Advisory Action

09/681,896

LARRAIN ET AL.

According to Brignola, this can be seen in Figures 6 and 9. With

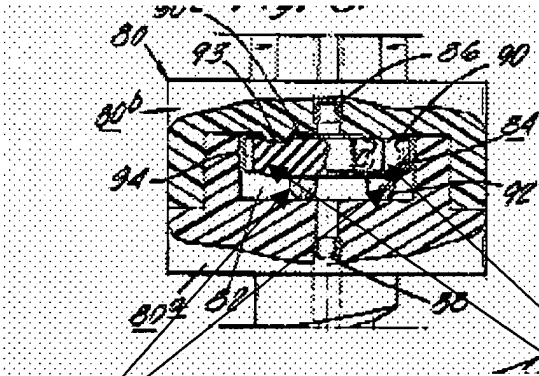
The applicant argues that the references do not teach the claimed invention, especially the structure of the mushroom shaped head, and piston with a stem. The examiner disagrees with the applicant because the term mushroom shaped head is broad and therefore the examiner gives this structural limitation a broad interpretation. The examiner interprets a piston member with a mushroom shaped head to mean, a valve that resembles a mushroom head. Mushroom heads can be curved or flat. There are several variations to mushroom heads and there is no specific shaped claimed. With regards to the arguments drawn to the piston stem, since the term comprising is used as the transition phase, the references can teach more than one stem, as long as one stem is taught, which is the case in the prior art references. The term comprises is referred to as the open term, meaning that the claimed invention can be taught as well as other elements or steps. The term consisting is a closed term, meaning that only the elements claimed are taught by the reference.

This is a stem. Since this claim uses the term comprising there can be more than one stems.

The mushroom shaped head. This structure resembles a mushroom.
